SUBMITTER No.	364	ISSUE REFERENCE:	13001
SUBMITTER TYPE	Government	TOR CATEGORY	Project Approvals
NAME	DEEDI (Fisheries Qld)	RELEVANT EIS SECTION	Volume 1 – Chapter 2 – 2.2.2 – Table 3

SUBMITTER No.	364	ISSUE REFERENCE:	13002 / 17144
SUBMITTER TYPE	Government	TOR CATEGORY	Project Approvals
NAME	DEEDI (Resource Planning, Geological Survey of Qld)	RELEVANT EIS SECTION	Volume 1, Project Overview (Chapter 2 – Project Approvals) Section 2.2.2 – State Legislation & Planning Policies

Figure 1. Rail Infrastructure Crossings (Sheet 4 of 5)

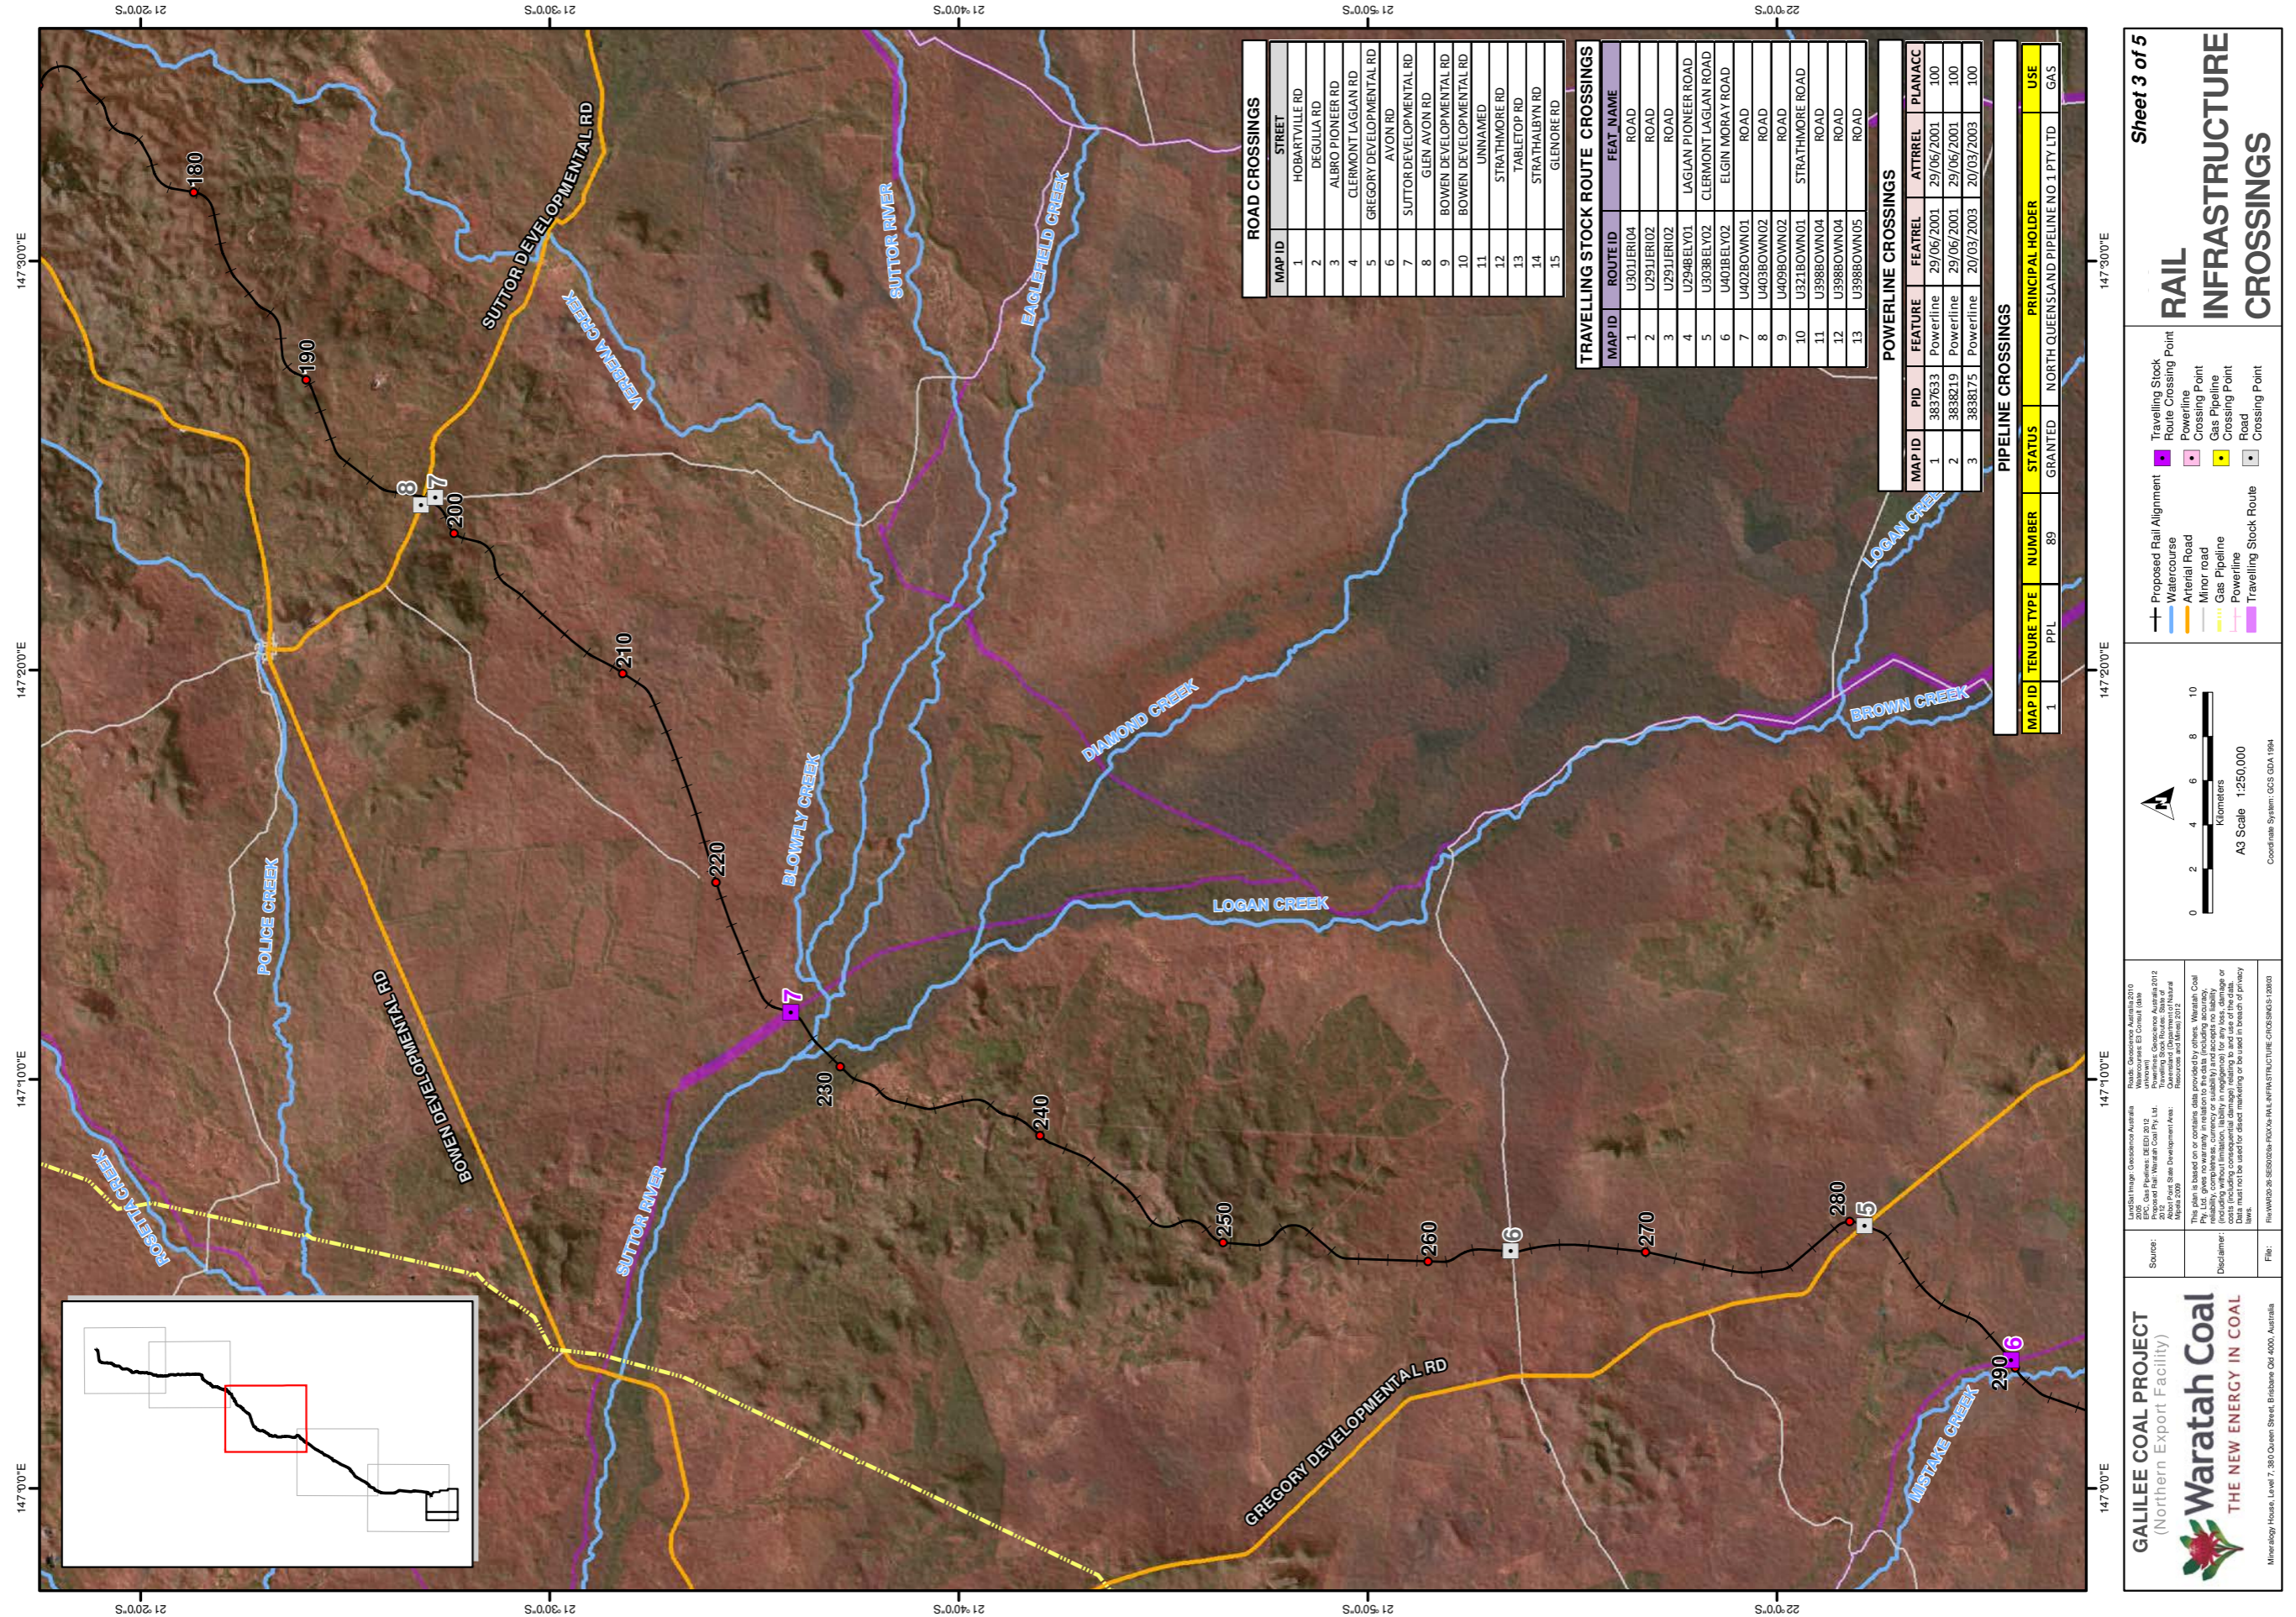
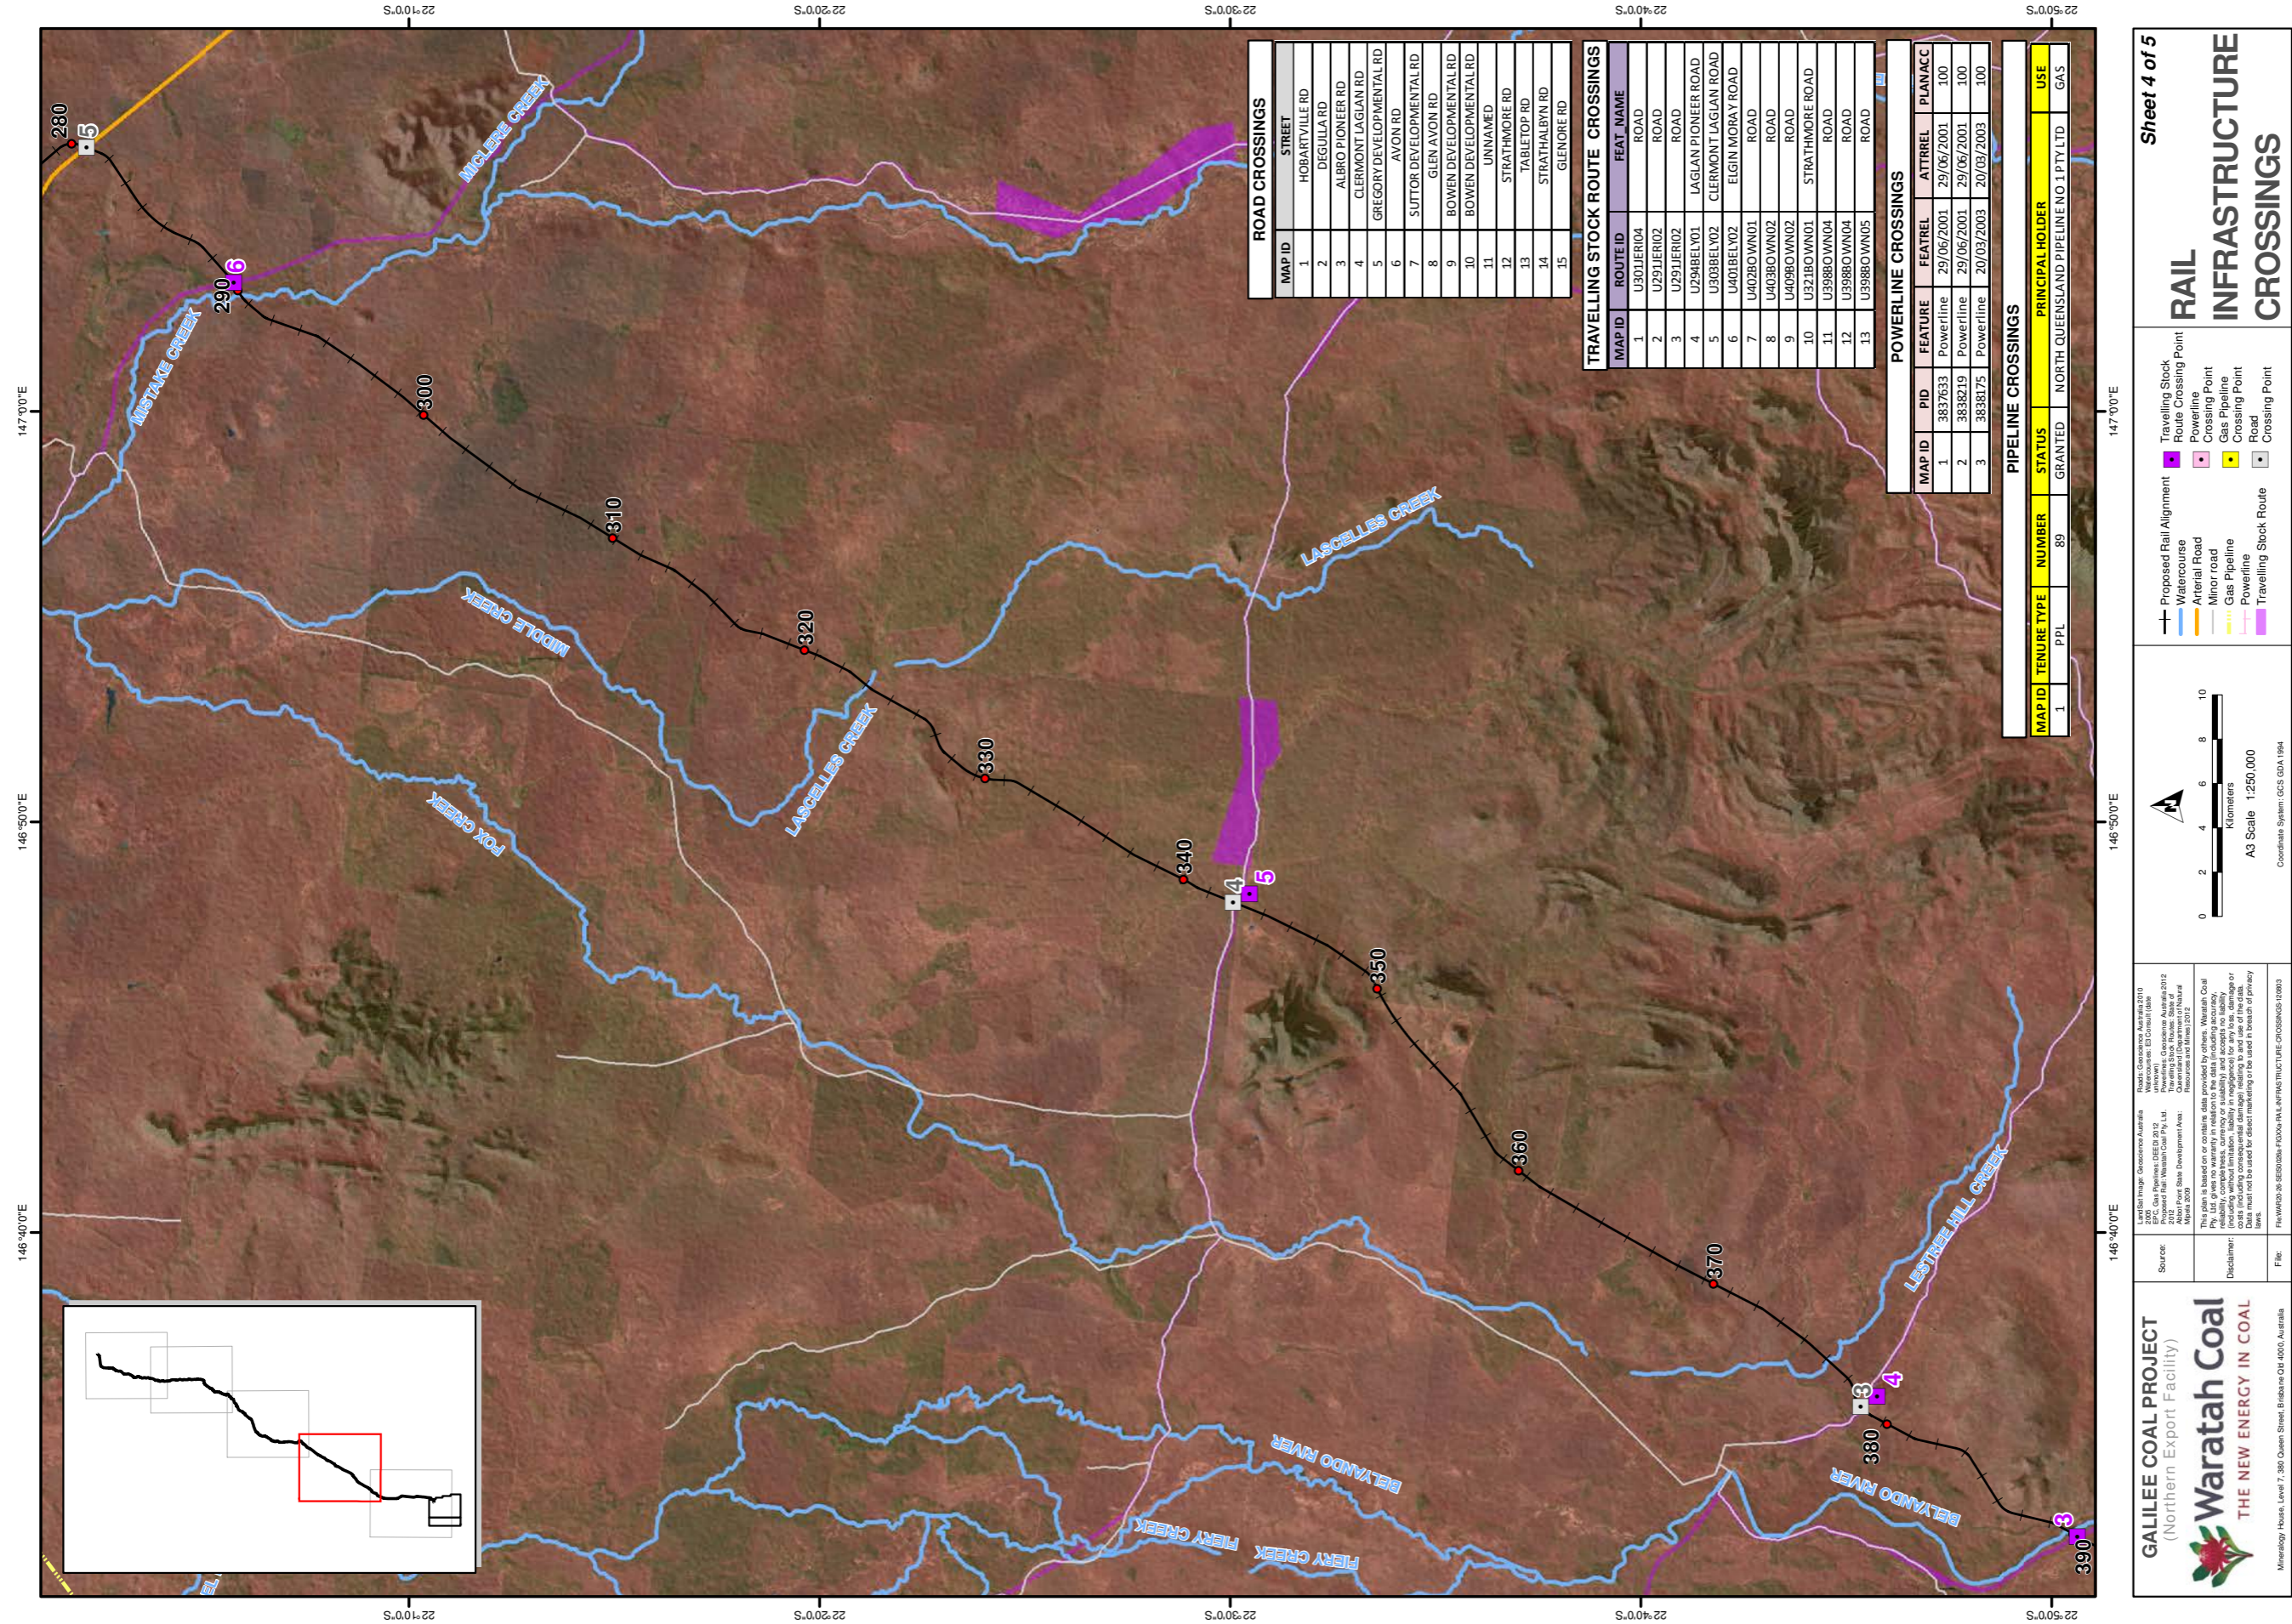
This section lists the relevant legislation affecting the Project. The proposed rail alignment traverses a constructed pipeline, the North Queensland Gas Pipeline (PPL 89).

Provisions of the *Petroleum and Gas (Production and Safety) Act 2004* (P&G Act) deal with activities affecting pipelines. This Act has not been identified in the draft EIS as part of the list of relevant legislation.

Reference should be made to the P&G Act, particularly Sections 807 and 808, which provide, respectively, that a person must not construct or place a structure on pipeline land without the prior consent of all the pipelines licence holders, and that a person must not change the surface of pipeline land without the prior consent of all the pipelines licence holders.

In accordance with the *Petroleum and Gas (Production and Safety) Act 2004* (P&G Act), Waratah Coal will obtain the necessary consents prior to undertaking any works over or near the subject pipeline.

Future studies regarding the portion of the rail alignment that traverses the North Queensland Gas Pipeline (PPL89) will take into account the provisions of the P&G Act. See Figure 1 (Sheets 1 to 5) on the following pages.
